LEGAL DESCRIPTION: Tracts B-1-A-1 and B-1-B-1, COMANCHE BUSINESS PARK, Albuquerque, Bernalillo County, New Mexico.

GRADING AND DRAINAGE PLAN
TRACTS B-1-A-1 & B-1-B
COMANCHE BUSINESS PARK
SITE GRADING

G-16/D82B — G-16 — 1/3

GRADING AND DRAINAGE PLAN
TRACTS B-1-A-1 & B-1-B-1
COMANCHE BUSINESS PARK
DRIVE PAD AND INLET

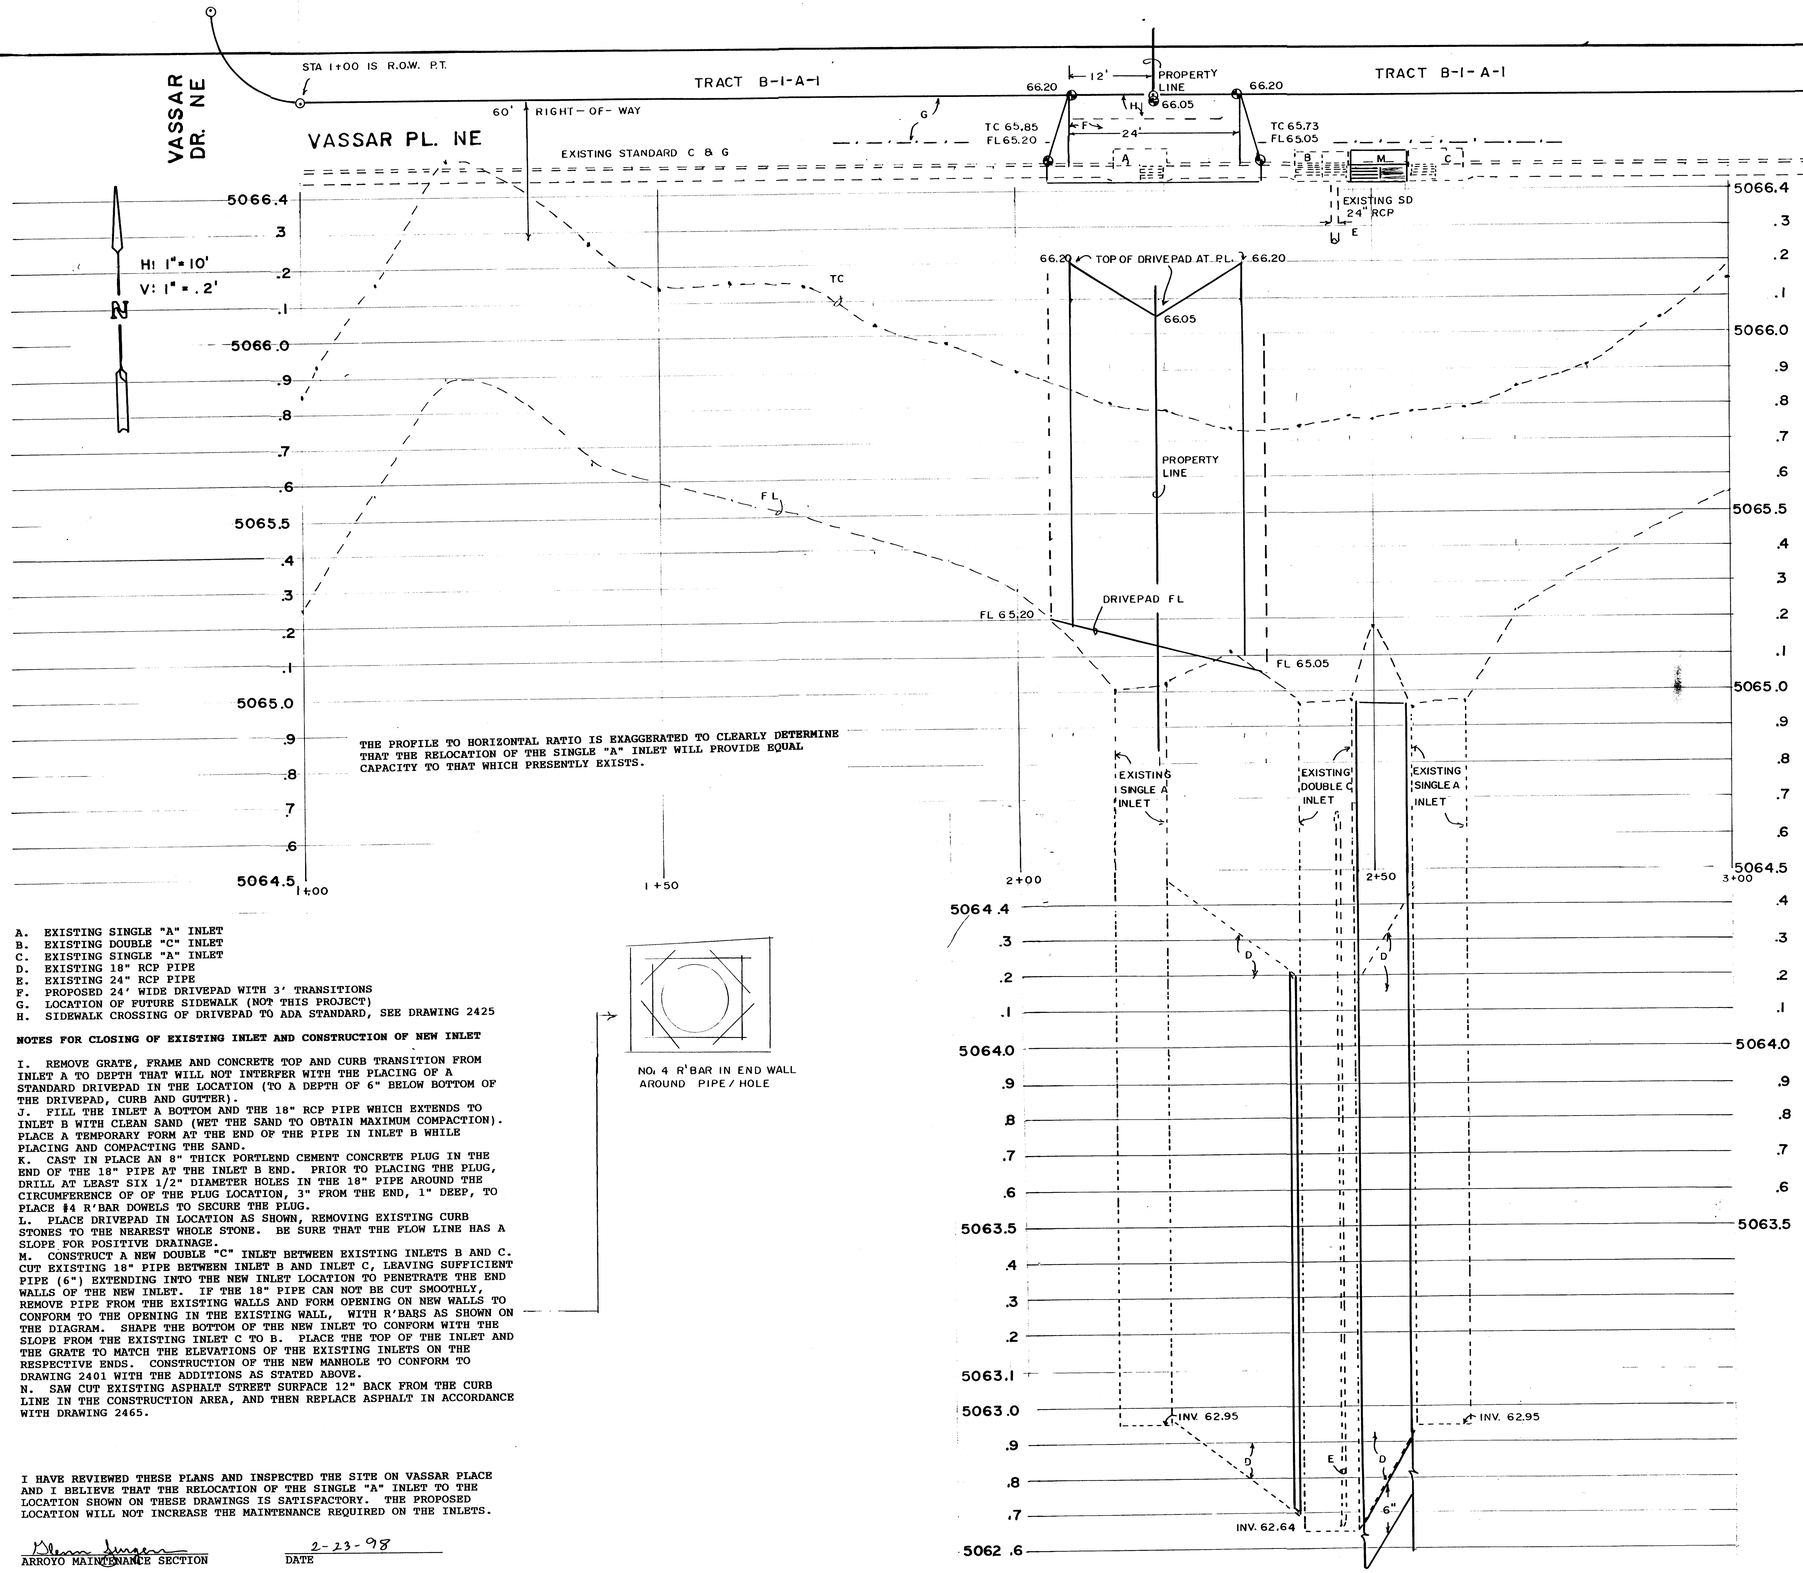
I HAVE REVIEWED THESE PLANS AND INSPECTED THE SITE ON VASSAR PLACE AND I BELIEVE THAT THE RELOCATION OF THE SINGLE "A" INLET TO THE LOCATION SHOWN ON THESE DRAWINGS IS SATISFACTORY. THE PROPOSED LOCATION WILL NOT INCREASE THE MAINTENANCE REQUIRED ON THE INLETS.

GRADING AND DRAINAGE PLAN
TRACTS B-1-A-1 & B-1-B-1
COMANCHE BUSINESS PARK
SITE GRADING

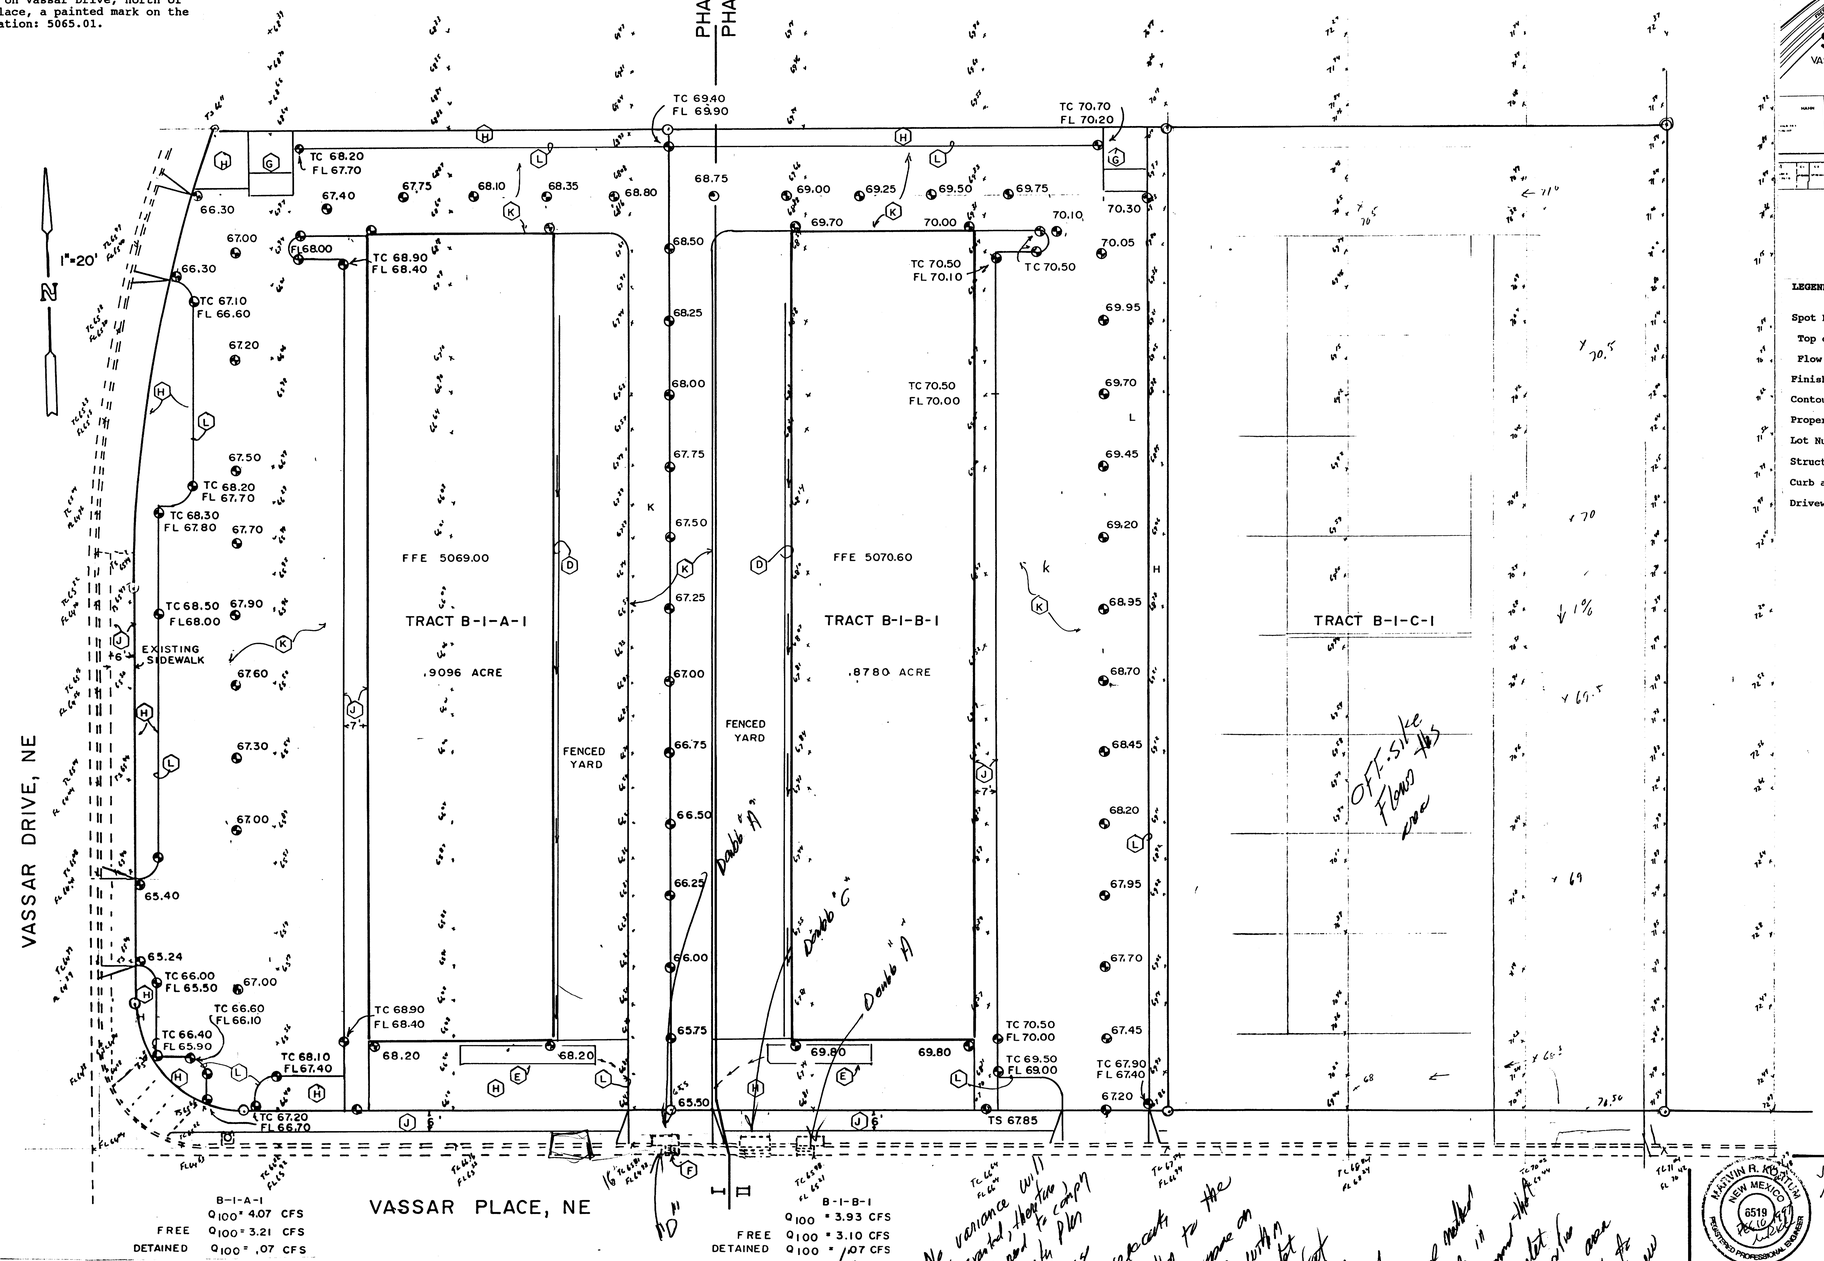
1. No variance will be granted, therefore you will need to comply with the Master plan
2. cross-lot drainage
3. You will need to relocate the Double "A" further to the west, if you still propose on locating the double "A" inlet
4. ADD PHASE I, II LINE

5. The new based method is not acceptable in this situation. Recommend you provide an inlet box in the centerline of the parking area with a curb opening of the proposed new double "A" inlet

GRADING AND DRAINAGE PLAN
TRACTS B-1-A-1 & B-1-B-1
COMANCHE BUSINESS PARK
SITE GRADING

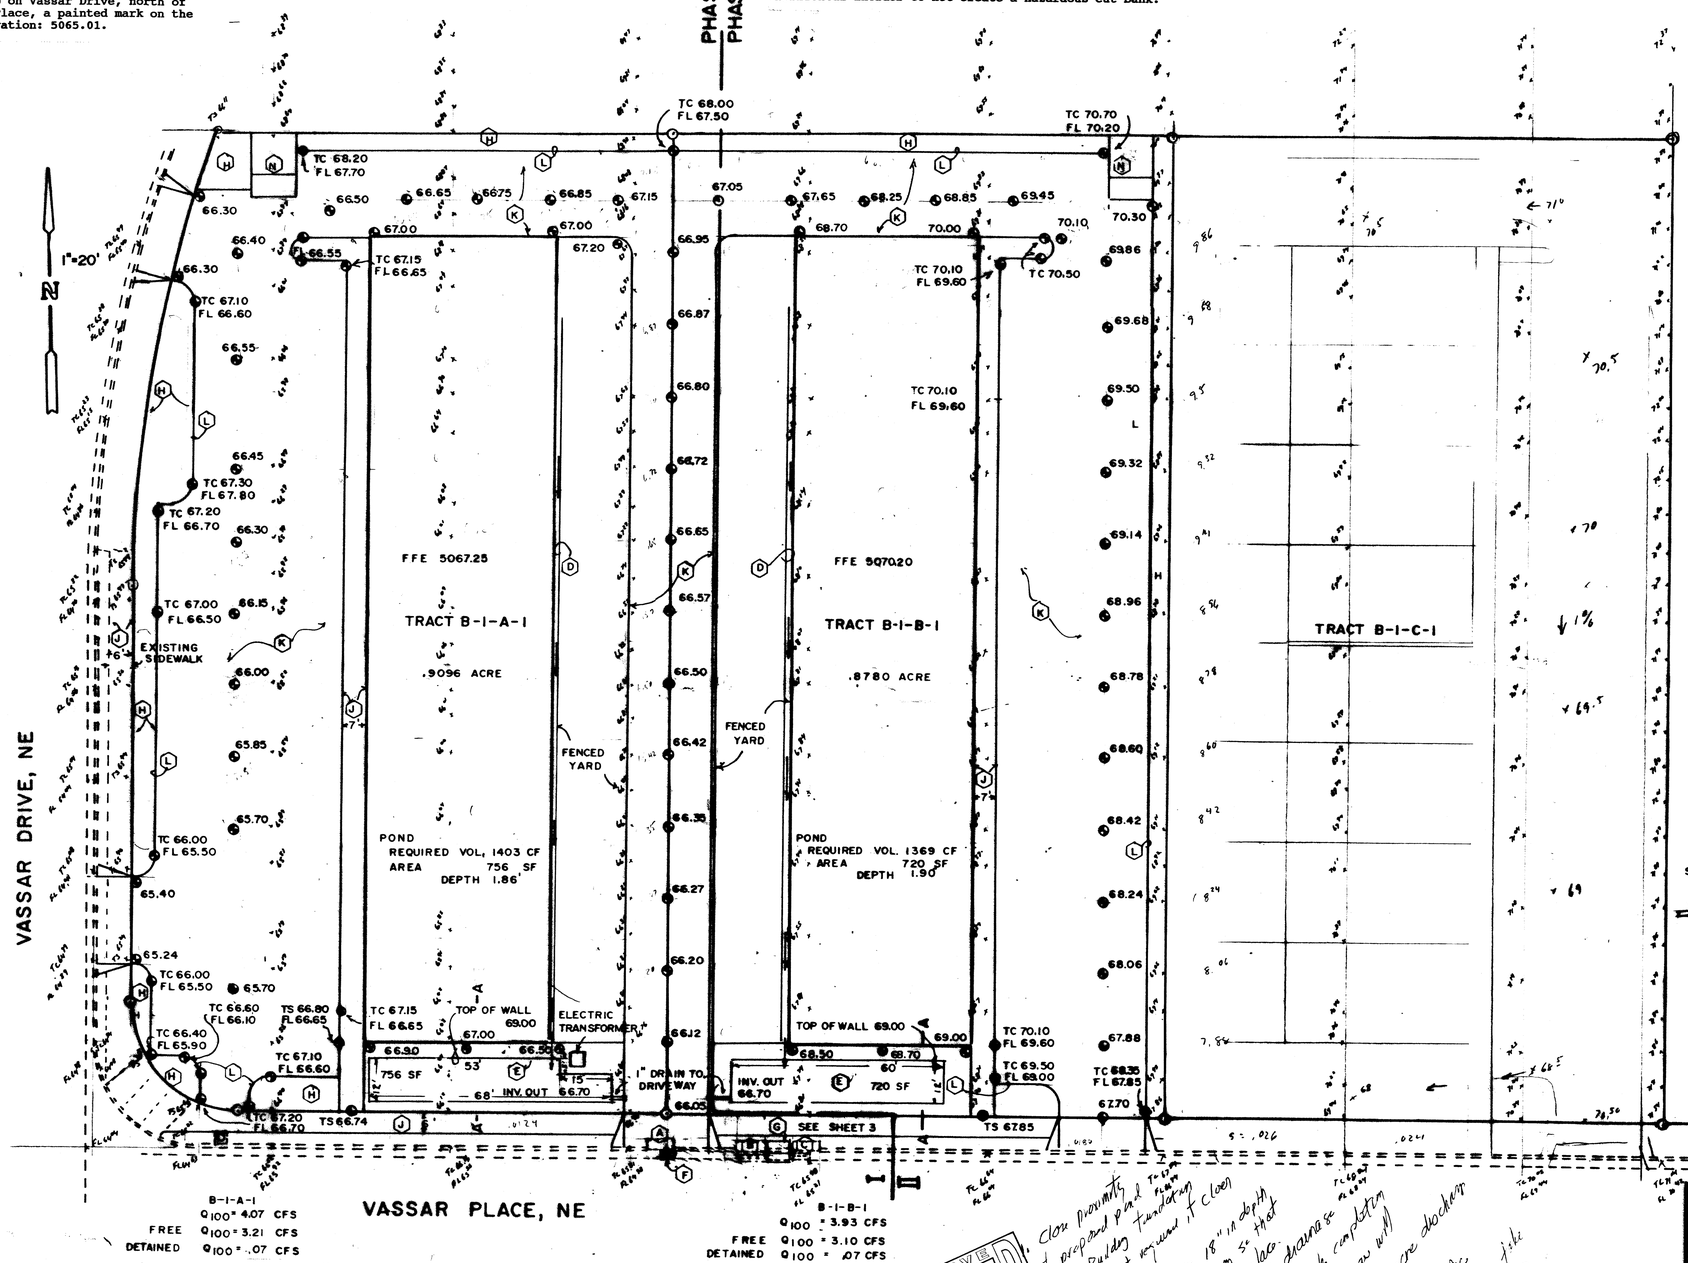
1. Close proximity of proposed pad to the Building Sails repout foundation than 1.5' pads state than 18" in depth
2. pads state 5" that will require some tonsoil 5" that no infiltration can take place.
3. According to the Master drainage plan concepts, only after the completion of SP 216 is completed the 361 ctg/gore dockets will be issued that time all the comments must be resolved to the
4. You design should be in accordance with the Master drainage plan.
